CONSIDERATION OF AND/OR ANY APPROPRIATE ACTION ON PANORAMA STREET PRELIMINARY PLAT, SITUATED IN THE PHILLIP ANDERSON SURVEY, ABSTRACT NO. 10 CITY OF PARKER, COLLIN COUNTY, TEXAS. [MACHADO]

Re: Panorama Street
 Preliminary Plat and Engineering Plan Review

As you requested, we have reviewed the Preliminary Plat & Engineering Plans for the Panorama Street Addition prepared by LJA Engineering, Inc. These documents include a new street and is therefore considered a major subdivision under section 155.025 of subdivision ordinance.

PRELIMINARY **LJA PROJECT ID**
NT561-0133
THIS DOCUMENT IS RELEASED
FOR THE PURPOSE OF
REVIEW
UNDER THE AUTHORITY OF
VERONICA B. HADLEY, TEXAS P.E.
#143748 ON
06/27/2023
THIS DOCUMENT IS NOT TO BE
USED FOR THE PURPOSES OF
CONSTRUCTION.
SCALE
HORZ: 1" = 100'
VERT: N/A
SHEET
4
OF 35 SHEETS

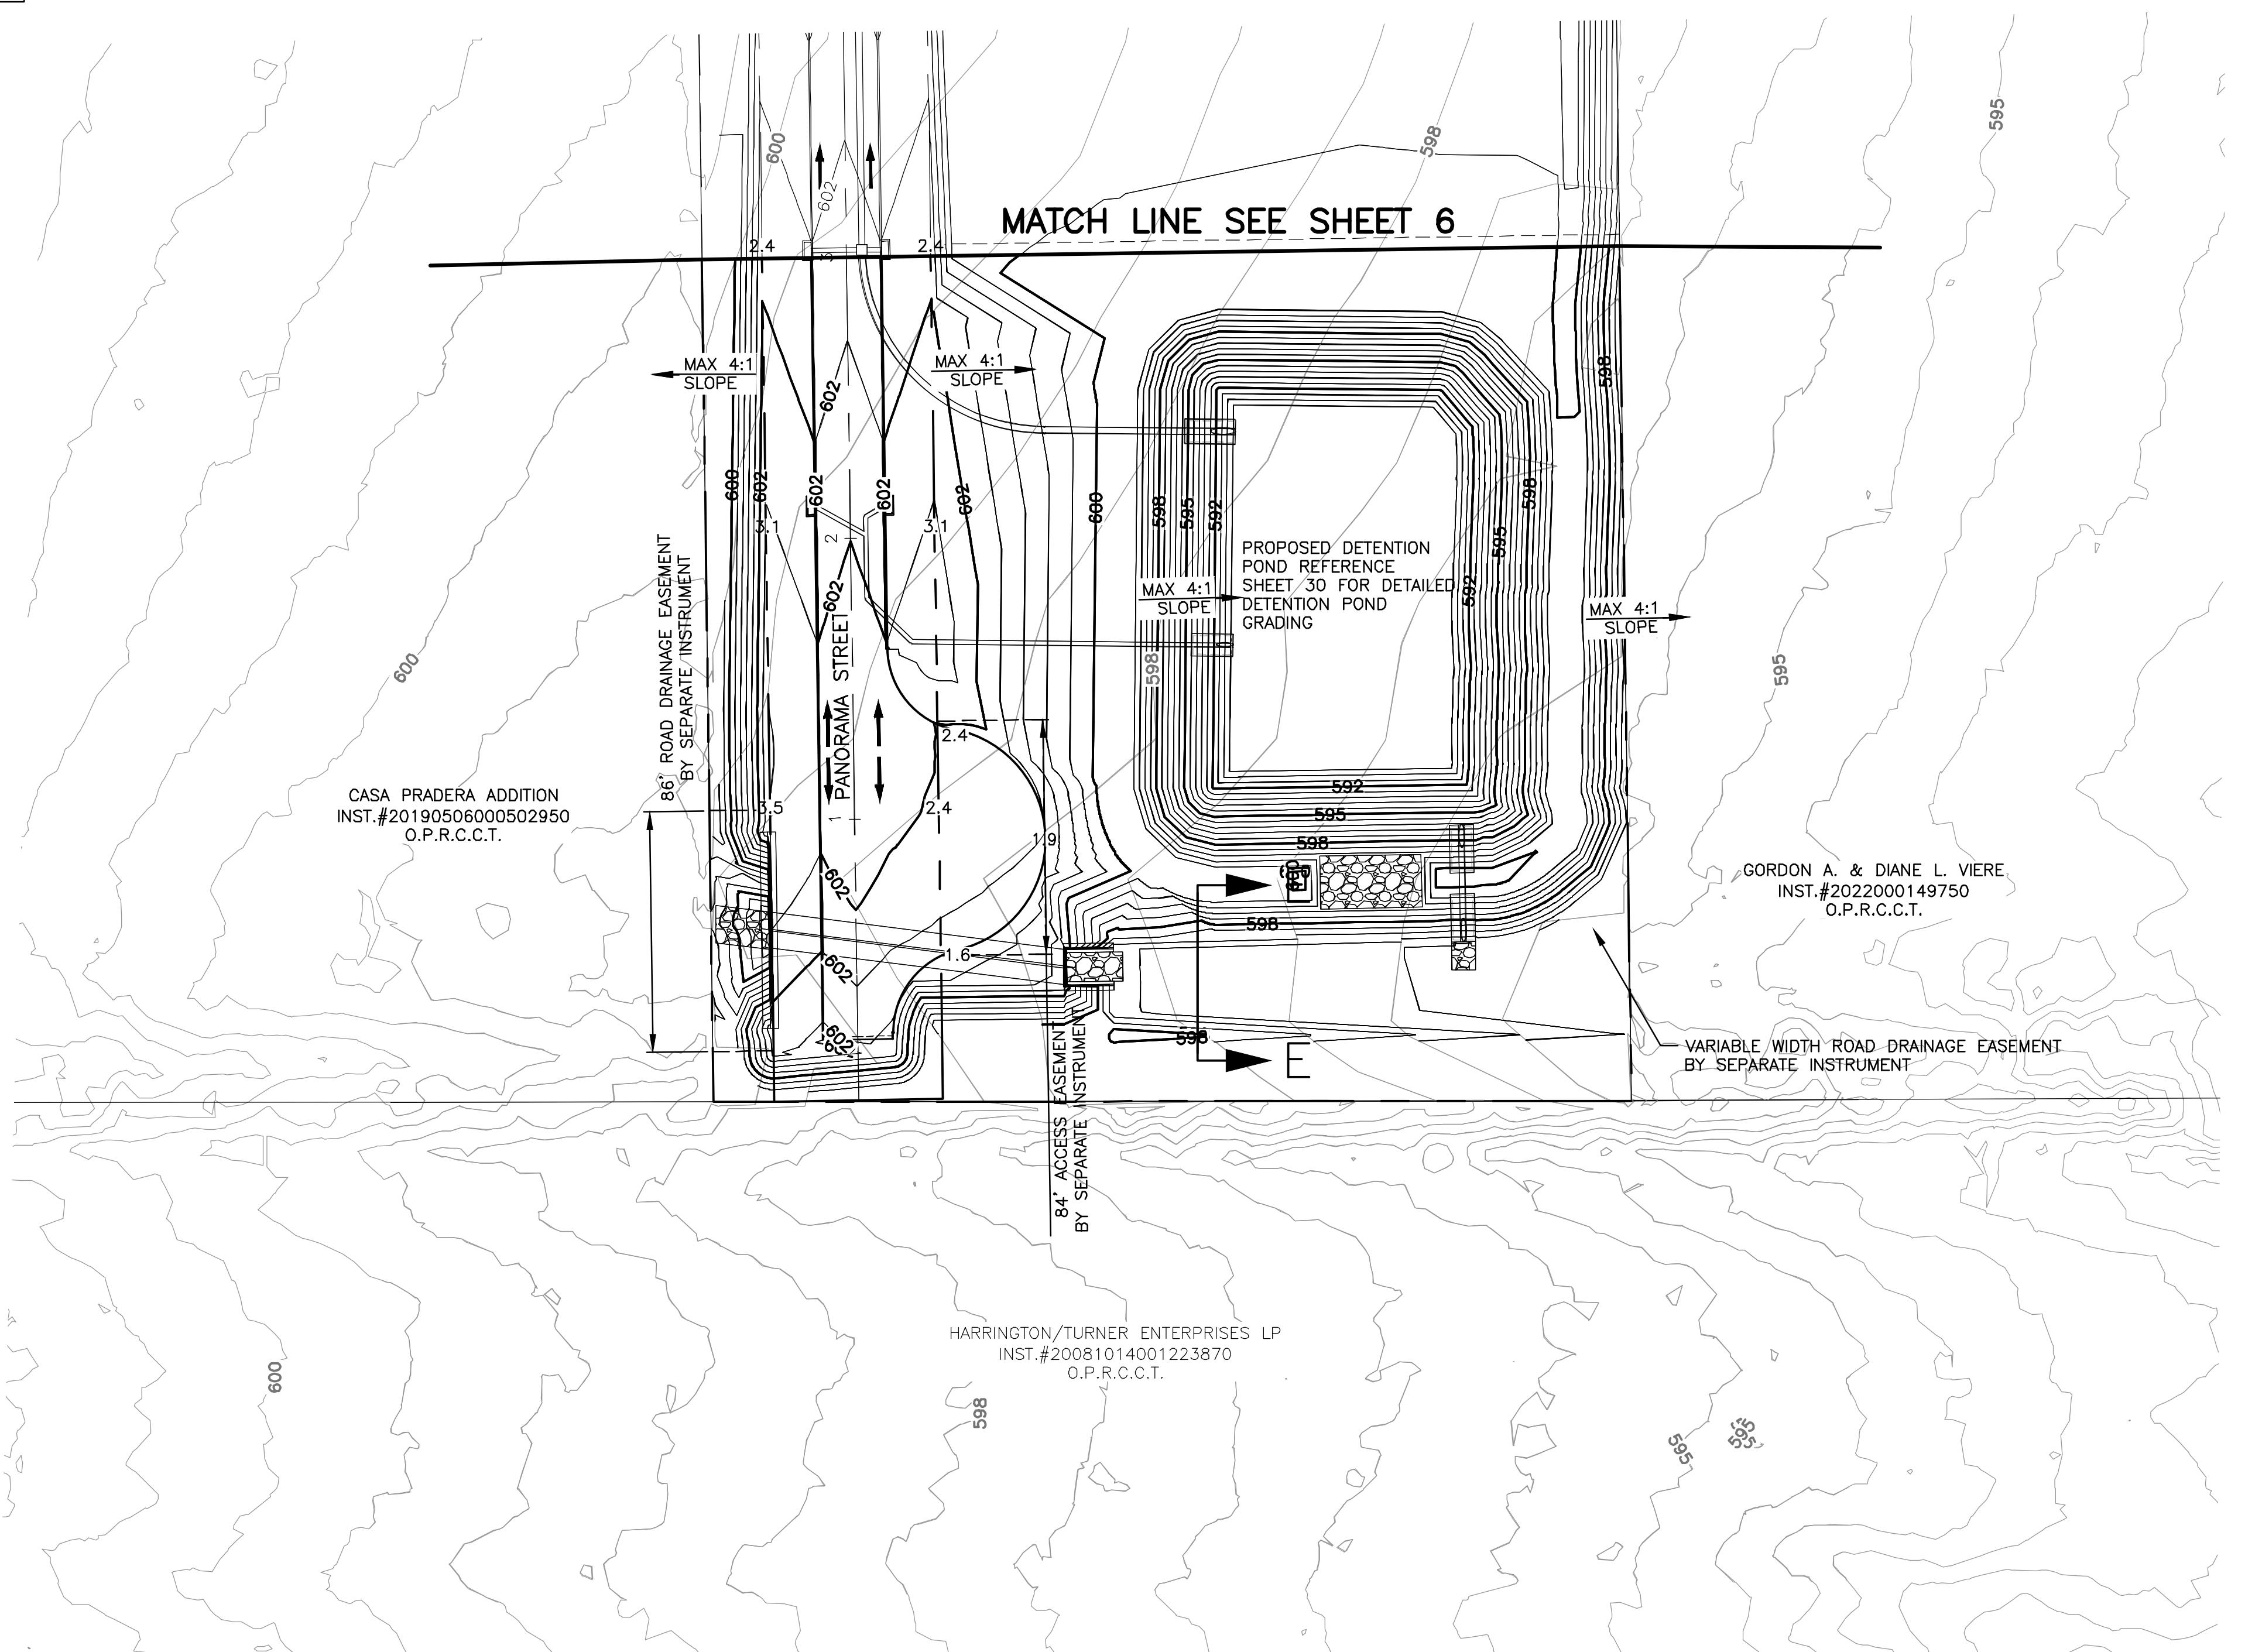
28. The Collin County Municipal Utility District No. 7 does not exist. Remove reference from plat.
29. Sheet 4 Provide details of new fences being proposed. Add note how to protect livestock when existing fences are removed.

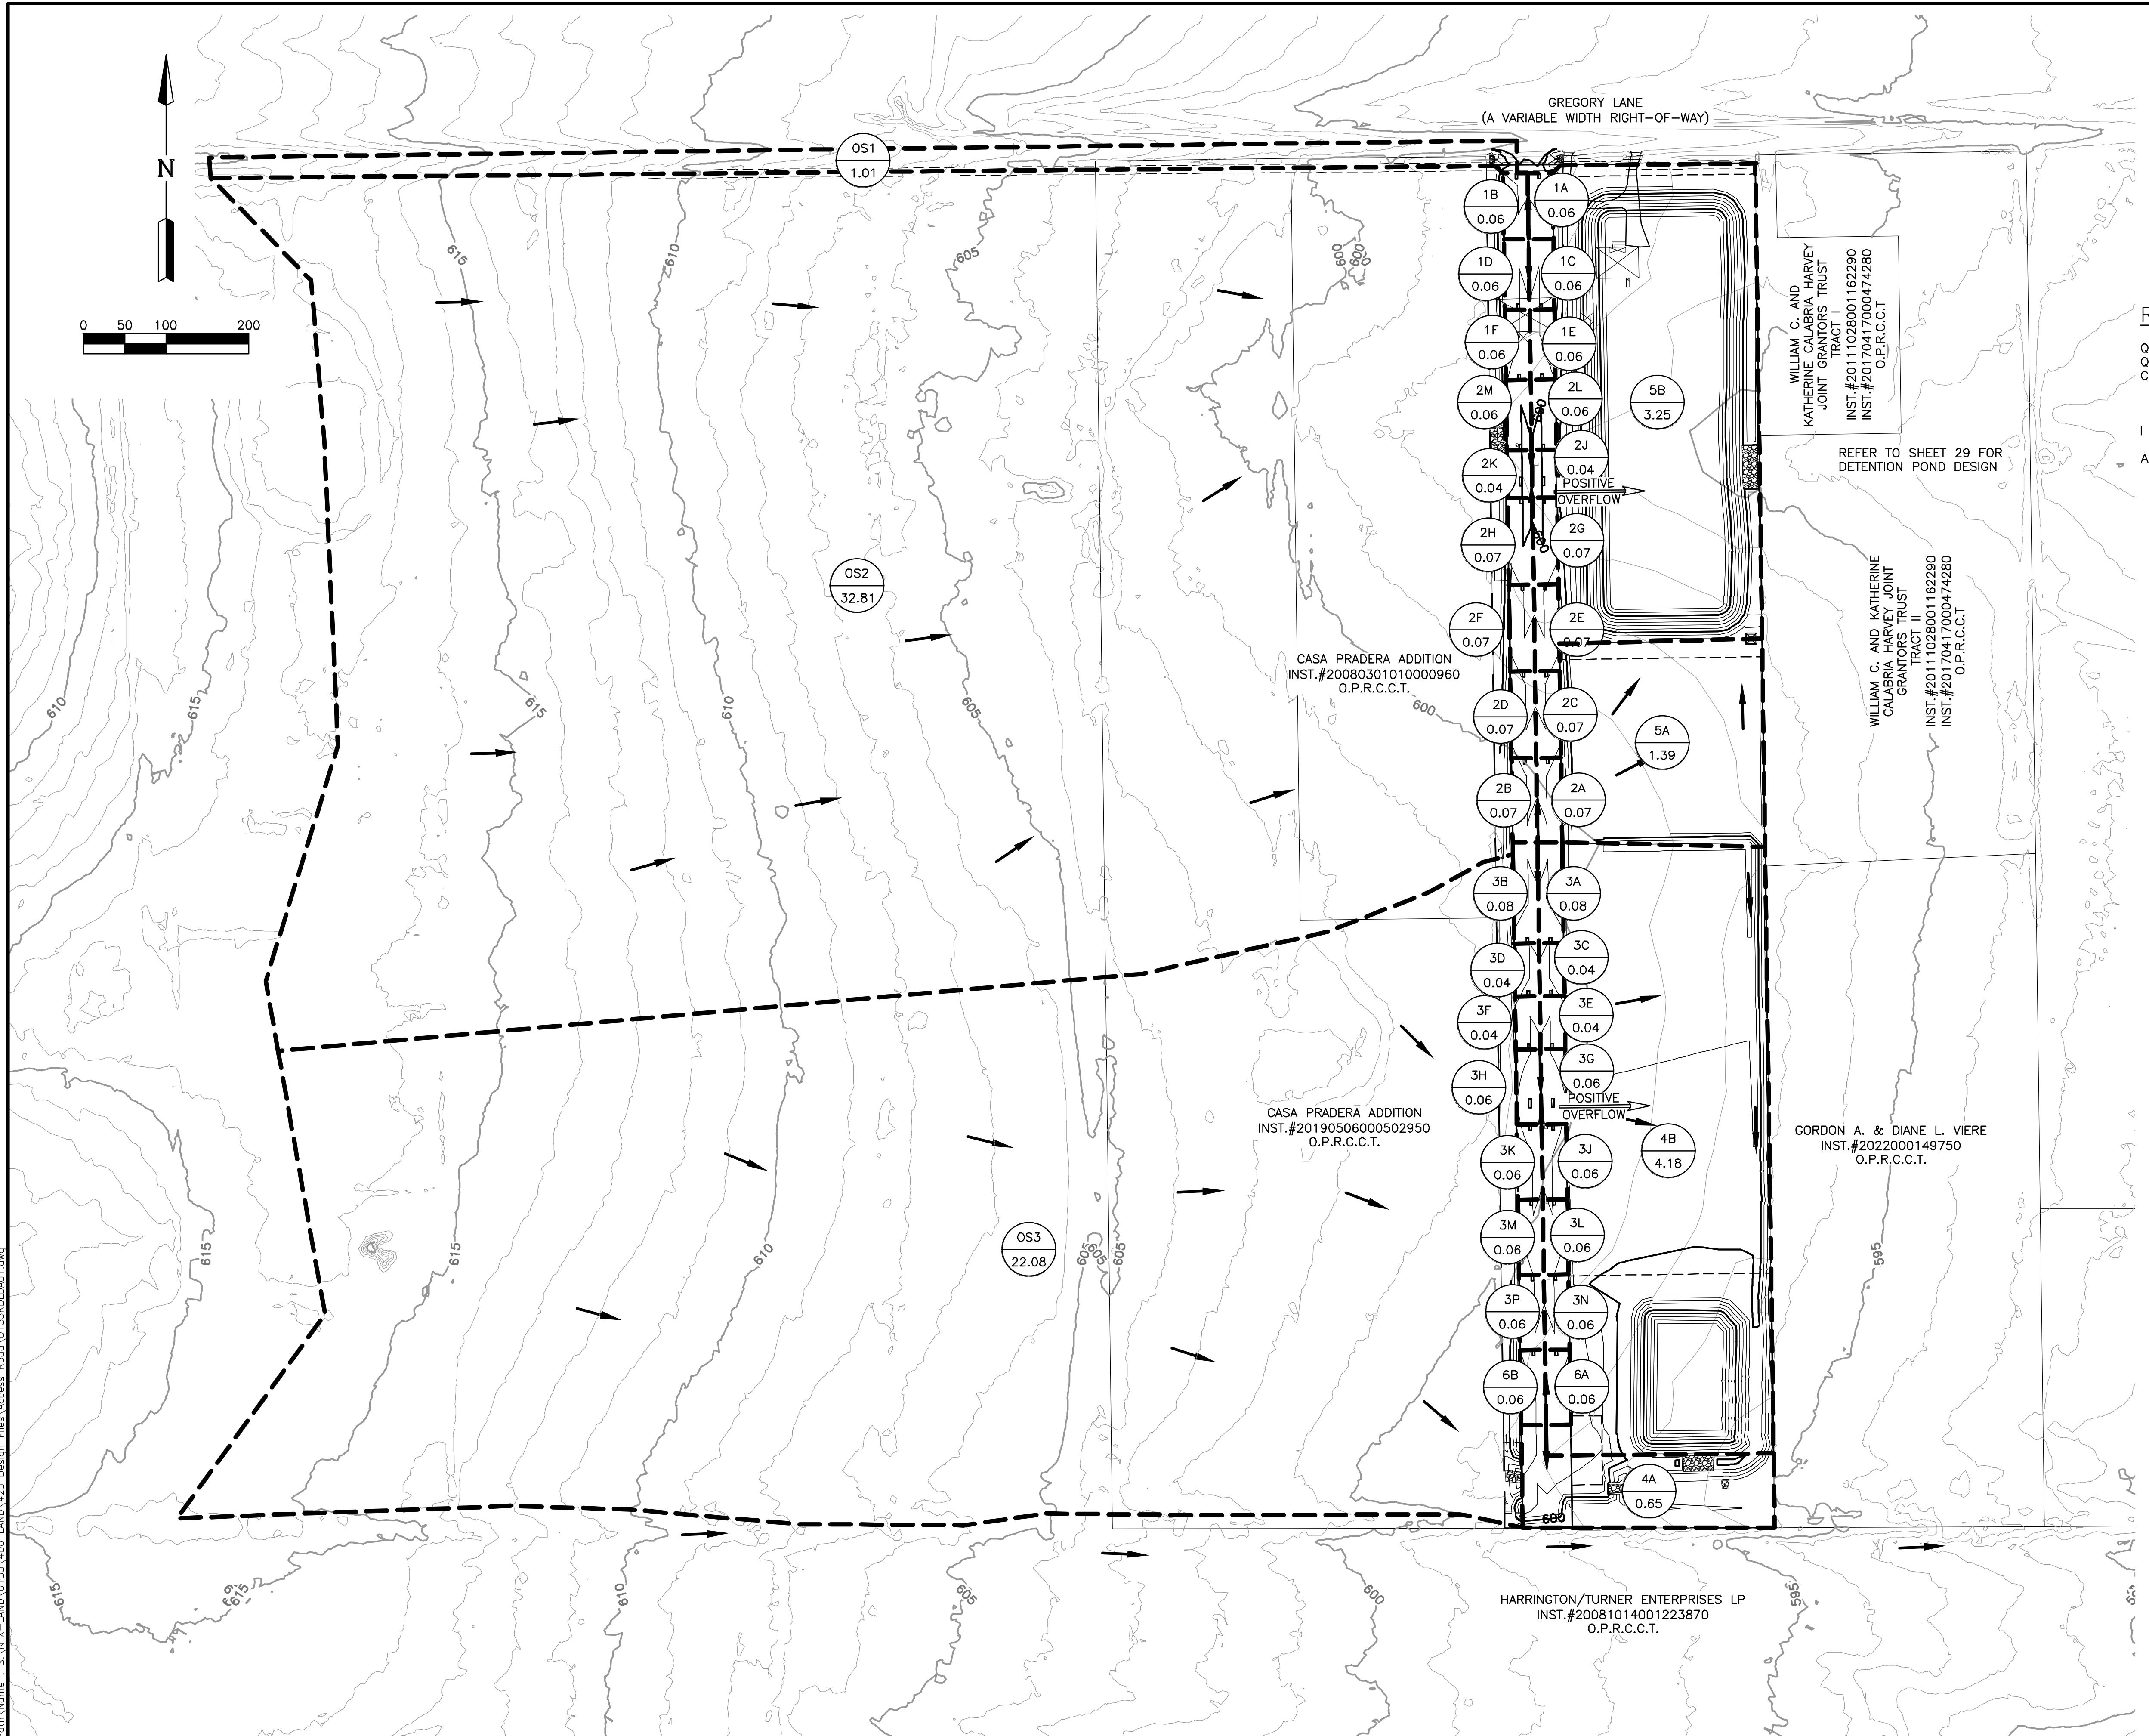
38. Sheet 14 shows overflows from the retention ponds that discharge through property with no designed channel to reach Maxwell Creek. Positive overflow channel must be paved. Drainage easement required. Appears the North Retention pond should overflow into Gregory drainage ditch (Improved) and not through the middle of the adjacent property owner's property.
